**STAFF RECOMMENDATION**  
**1504 Elmwood Avenue**  
**June 20, 2012**

**Application:** Infill and New construction—accessory structure  
**District:** Belmont-Hillsboro Neighborhood Conservation Zoning Overlay  
**Council District:** 18  
**Map and Parcel Number:** 10513011200  
**Applicant:** Rigid Development (Brent Craig)  
**Project Lead:** Melissa Baldock, melissa.baldock@nashville.com

<p><b>Description of Project:</b> Applicant proposes to construct a new one-and-a-half story house and a two-story accessory structure on a vacant lot.</p> <p><b>Recommendation Summary:</b> Staff recommends approval of the construction of the infill building and accessory structure with the conditions that:</p> <ol style="list-style-type: none"> <li>1. The applicant submit new drawings indicating how the grade will be addressed in the new construction, particularly as it relates to the infill’s foundation line and the overall height of the house. (The foundation should have a maximum height of about two feet (2’)).</li> <li>2. Staff approve the house’s asphalt shingle color, final door design, a brick sample, porch floor and stair material, porch railing material, and the porch column shaft m

**FRONT ELEVATION**  
 SCALE: 1/4" = 1'-0"

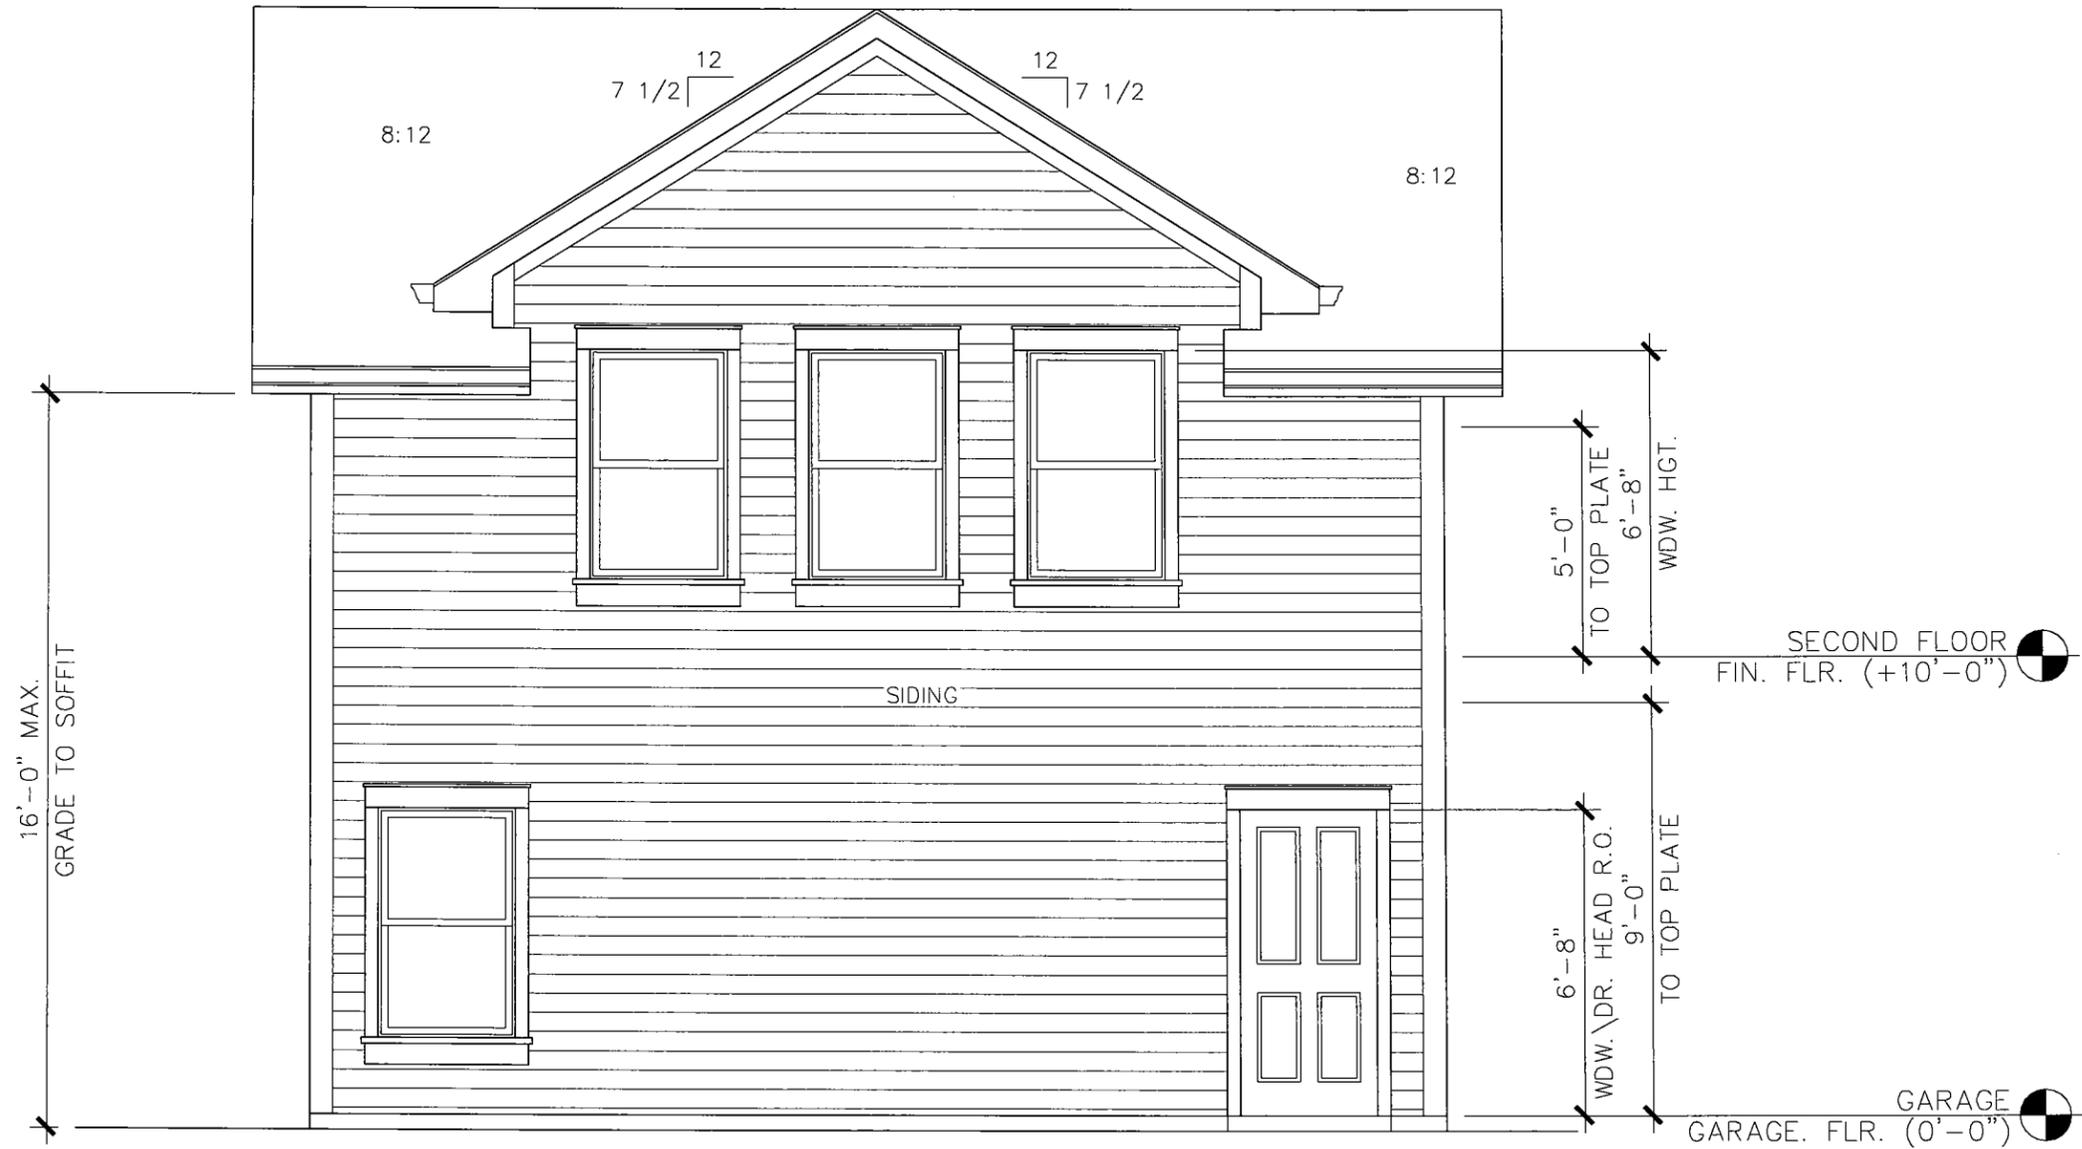
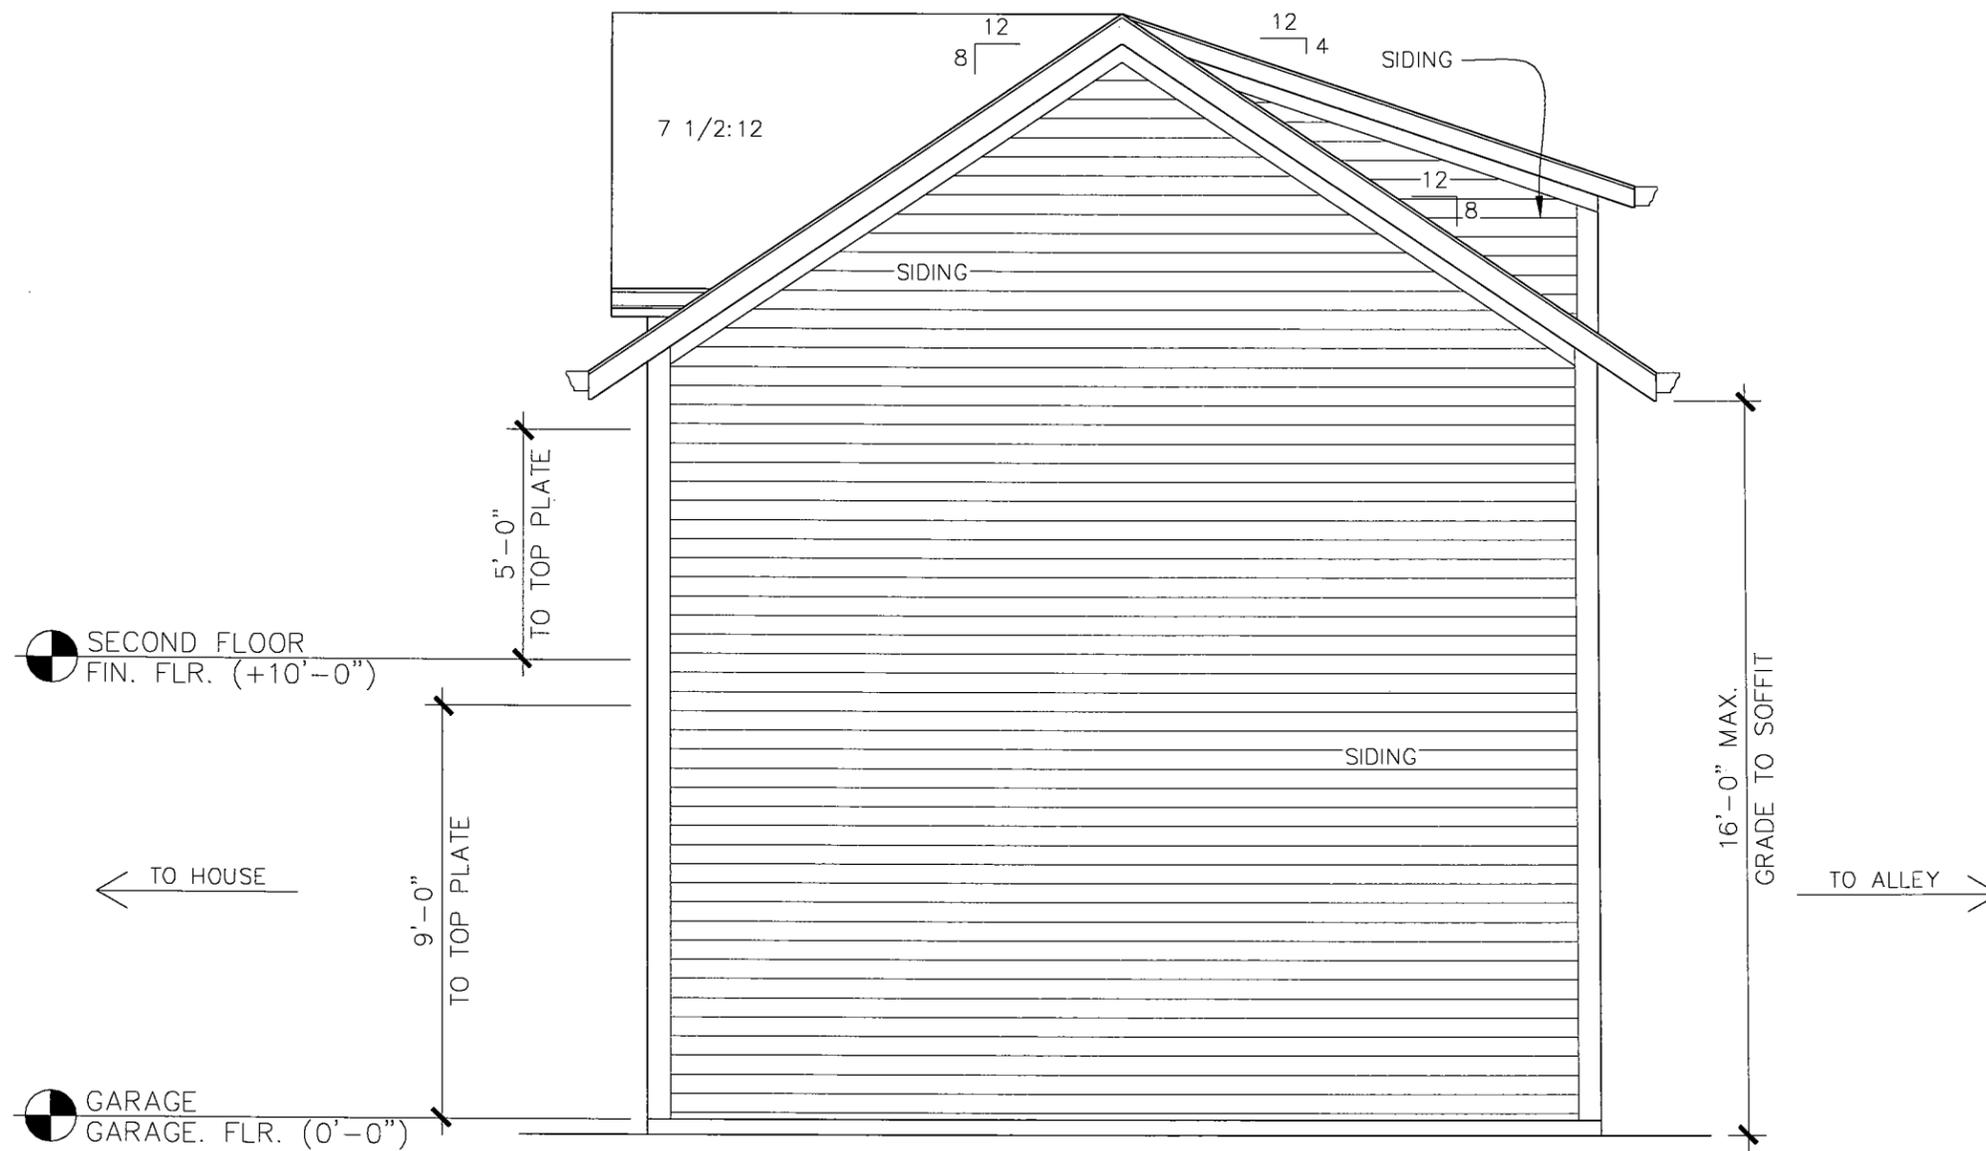
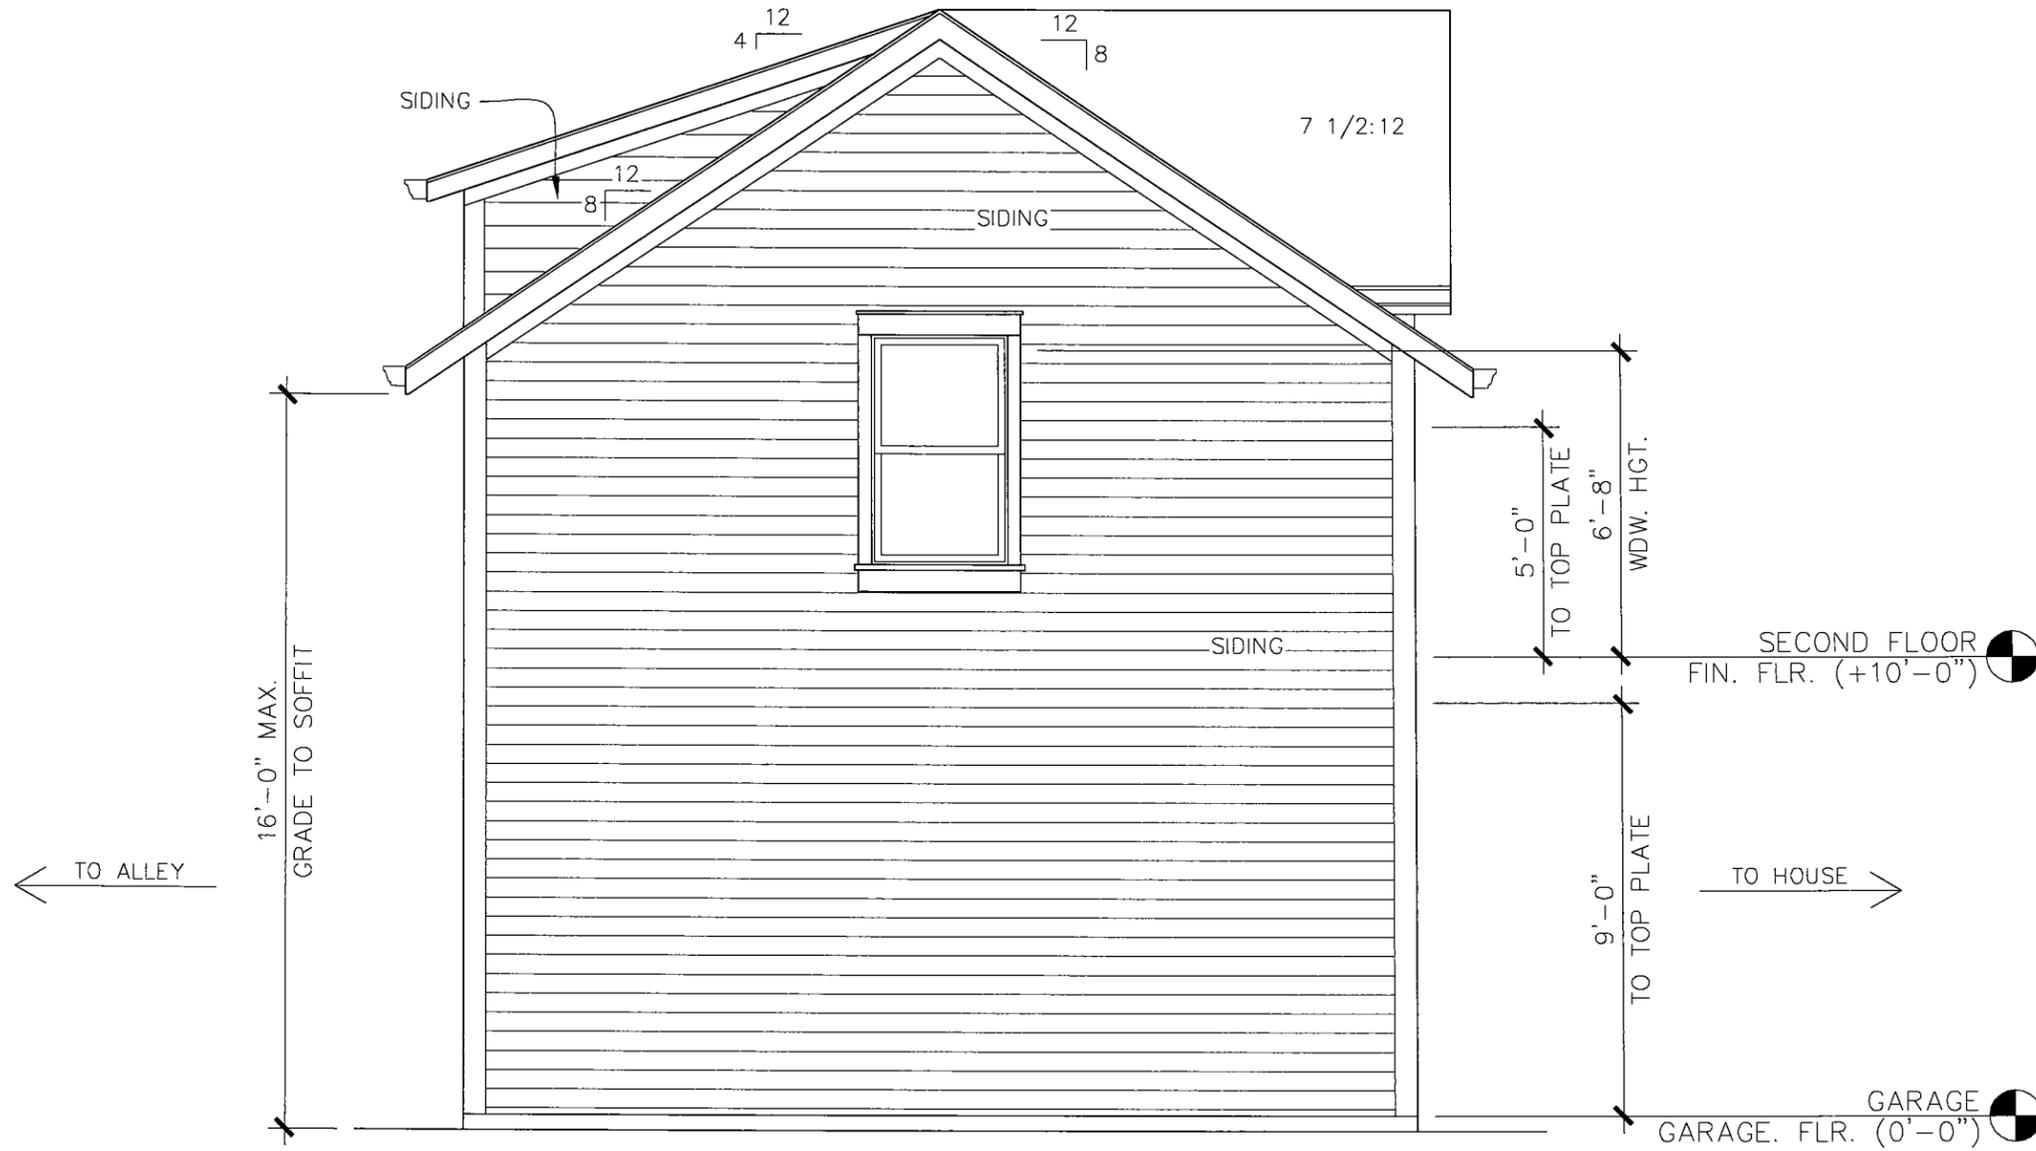
Outbuilding: The project includes a detached accessory structure that is twenty feet, seven inches by twenty-four feet, seven inches (20'7" x 24'7"). This footprint is subordinate to the primary house. The structure meets all base zoning requirements for setbacks, and will be accessed via the alley with garage doors facing the alley. The materials for the structure will be cement fiberboard siding and composite shingle roof. Staff asks to review and approve the window and door materials and specifications and the roof color prior to purchase and installation of these materials.

The accessory structure is proposed to have an eave height of sixteen feet (16') and a ridge height of twenty-four feet, six inches (24'6"). Since the site slopes up towards the rear of the lot, staff finds that more information is needed regarding the slope of the site before determining whether or not the height of the accessory structure is subordinate to the proposed infill. Staff also asks that a trim board be added to the garage at the floor level to help minimize the perceived height of the structure.

6. Staff review the height of the accessory structure relative to the slope of the site prior to permitting to ensure that it is subordinate to the infill.

7. A trim board be added to the accessory structure's floor level, and staff approve all of the structure's windows, doors, and roof color.
